Re: C15-2019-0063

BOA GENERAL REVIEW COVERSHEET

BOA DATE: January 13th, 2020 **CASE**: C15-2019-0063

ADDRESS: 1507 Fairfield Dr. **COUNCIL DISTRICT:** 7

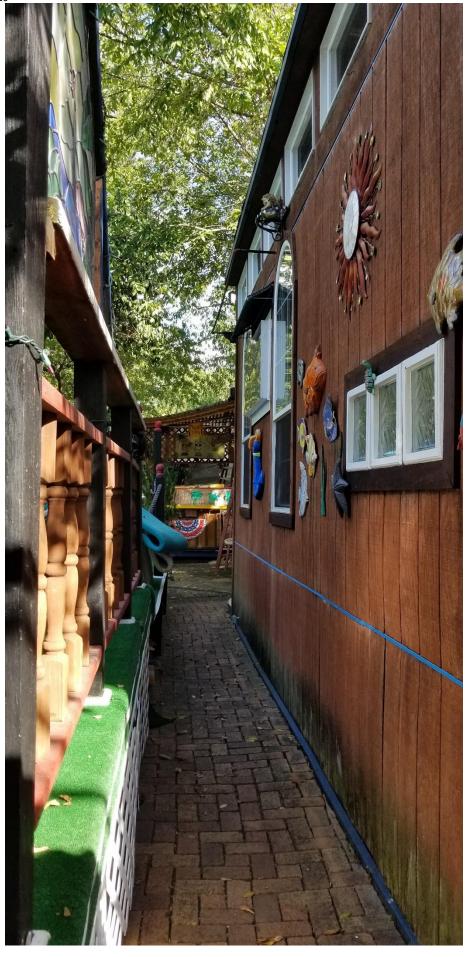
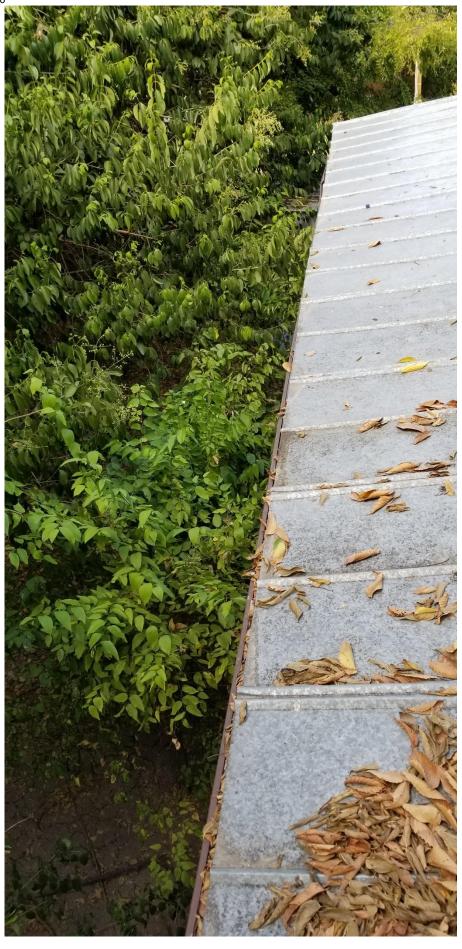
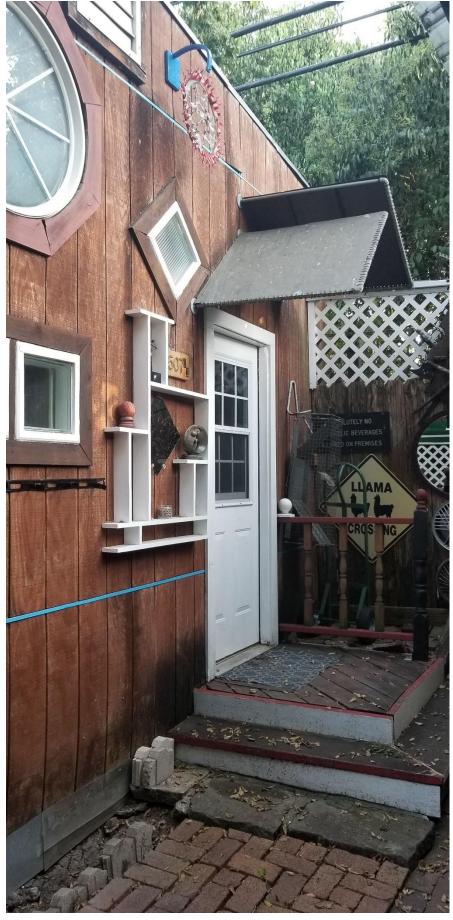
DENIED BY AUSTIN ENERGY (AE), due to applicant having a permanent structures that conflict with Austin Energy's clearance requirements. The Customer's facilities/installations shall maintain clearances from AE overhead facilities as required in Section 234 of the NESC. See NESC Clearance Envelope below for typical NESC clearances of 12-foot 6-inch vertical and 7-foot 6-inch horizontal from AE overhead primary voltage lines. Contact AE Design for specific clearance information. In addition, the Customer's facilities shall not be installed under or over AE overhead distribution facilities and shall maintain a minimum horizontal clearance of 7'-6" from overhead AE distribution facilities.

It is recommended that you remove the features shown on the submitted survey, be relocated from outside the easement area and that they maintain the required electric clearance requirements.

DENIED BY AUSTIN ENERGY (AE), due to applicant having a permanent structures that conflict with Austin Energy's clearance requirements. The Customer's facilities/installations shall maintain clearances from AE overhead facilities as required in Section 234 of the NESC. See NESC Clearance Envelope below for typical NESC clearances of 12-foot 6-inch vertical and 7-foot 6-inch horizontal from AE overhead primary voltage lines. Contact AE Design for specific clearance information. In addition, the Customer's facilities shall not be installed under or over AE overhead distribution facilities and shall maintain a minimum horizontal clearance of 7'-6" from overhead AE distribution facilities.

It is recommended that you remove the features shown on the submitted survey, be relocated from outside the easement area and that they maintain the required electric clearance requirements.

The applicant has carried out the demolition and disassembly of the structures, in the rear portion of above address, therefore eliminating Austin Energy's clearance conflicts with the structures from the existing electric lines.

Therefore, **Austin Energy does not oppose the above variance request**, provided any proposed and existing improvements follow Austin Energy's clearance criteria requirements, the National Electric Safety Code and OSHA. Any removal or relocation of existing electric facilities will be at owners /applicants' expense.
